HOLDOVER
REVISED
OAKSTON SUBDIVISION

APPLICATION NUMBER Holdover DATE April 3, 2003

APPLICANT Oakston Subdivision

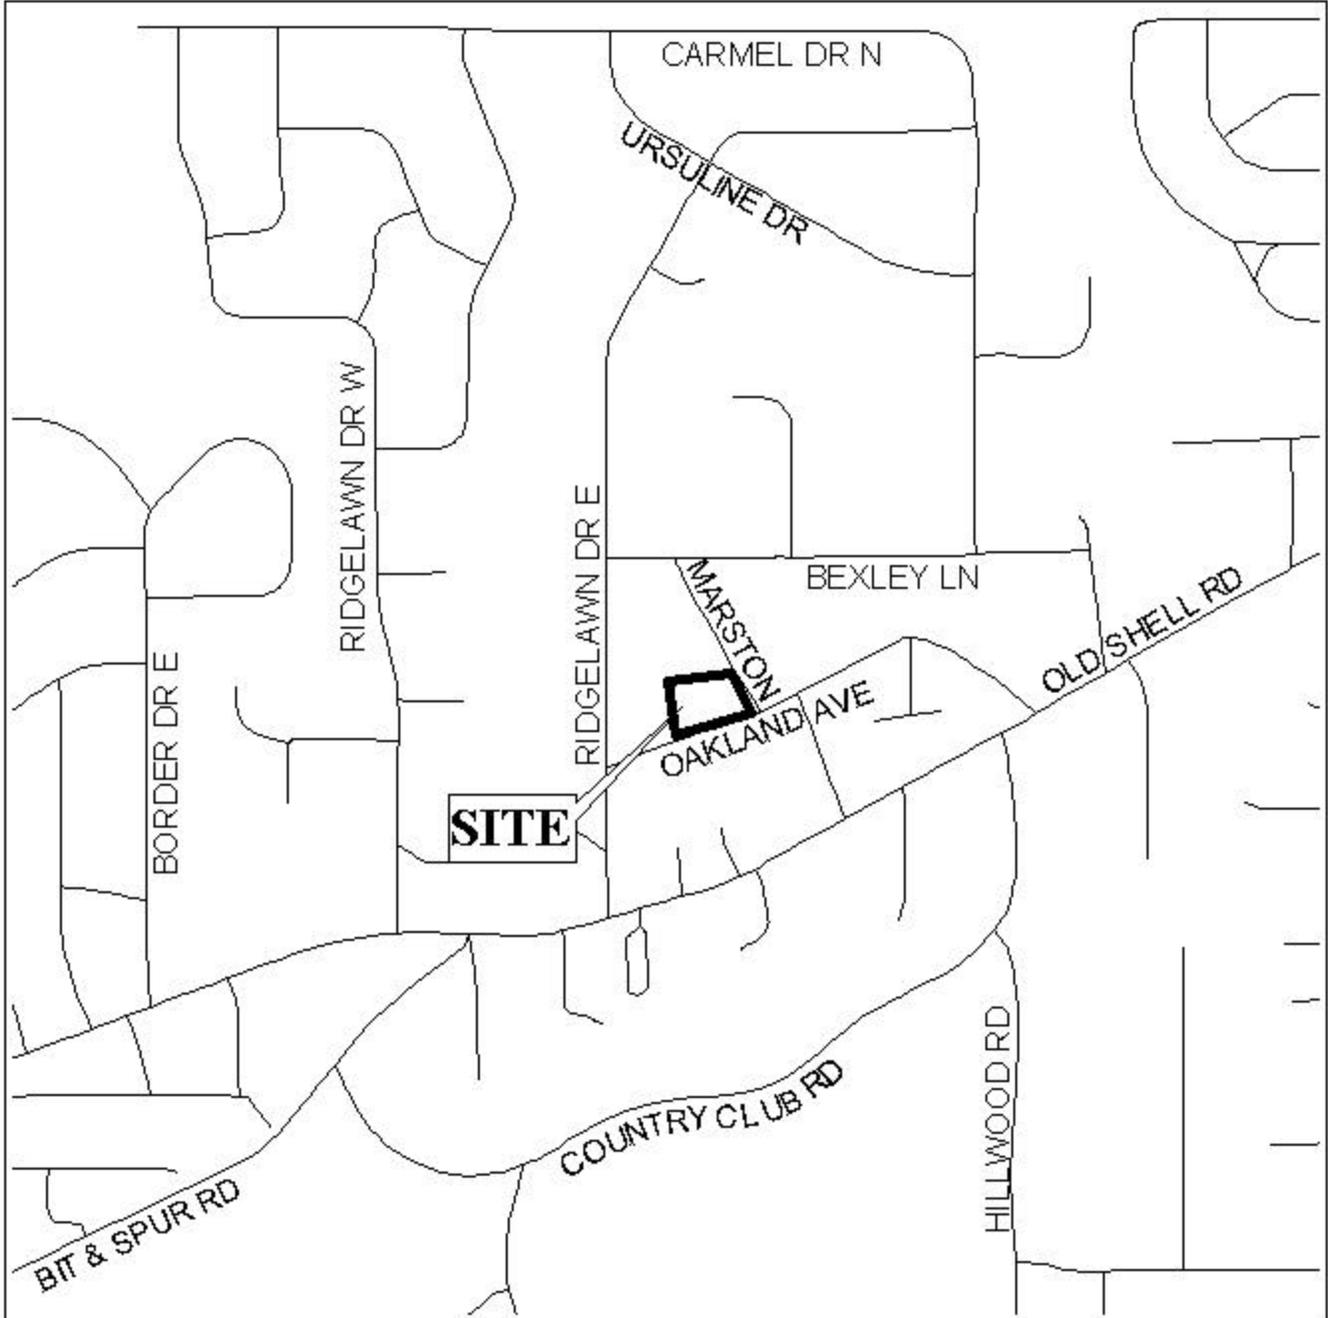
Marston Lane, which has an existing right-of-way of 40-feet, is a minor street, and as such requires a 50-foot right-of-way; therefore, the dedication of sufficient right-of-way to provide 25 feet from the centerline should be required. With Lot 3 being a corner lot, the dedication of a 25' radius should also be required.

As proposed, the width of Lot 3 would be 77-feet at the front property line to 57-feet at the rear property line. This reduction in lot width is a result of the dedication of right-of-way along Marston Lane. As illustrated on the Vicinity Map, a structure exists on Lot 2 which is not illustrated on the preliminary plat making it difficult to determine if the size of Lot 3 can be increased and if adequate setbacks on Lot 2 are provided. Section V.D.6. states that corner lots for residential use shall be increased in width over the minimum specified, so that front yard distance can be provided on both streets. Based upon the proposed plat configurations, Lot 3 would have considerably less “buildable area” (including all setbacks) than the other two proposed lots.

The applicant has submitted a revised plat reflecting the existing house on Lot 2 meeting the 8-foot minimum side yard setback. Lot 3 would actually be 84-feet wide at the front property line, however, the lot would be only 51-feet wide at the rear property line. Based upon this revision, the buildable area for Lot 3 would be 50-feet at the front setback line and 22-feet at the rear setback line (20-foot setback along Marston Lane and a 25-foot setback along Oakland Avenue). With this revision, Lot 3 would still not meet the requirements Section V.D.2. (which states that new lots be a minimum of 60-foot wide at the building setback line) of the Subdivision Regulations. Moreover, this proposed subdivision would create a self-imposed hardship for constructing a residence in compliance with the setback requirements of the ordinance.

*Based upon the preceding, this application is recommended for approval for a **two-lot** (Lot 1 and the combining of Lots 2 and 3 to create a second lot) subdivision with the following conditions: 1) the dedication of sufficient right-of-way to provide 25 feet from the centerline of Marston Lane; and 2) the dedication of a 25' radius at the intersection of Marston Lane and Oakland Avenue.*
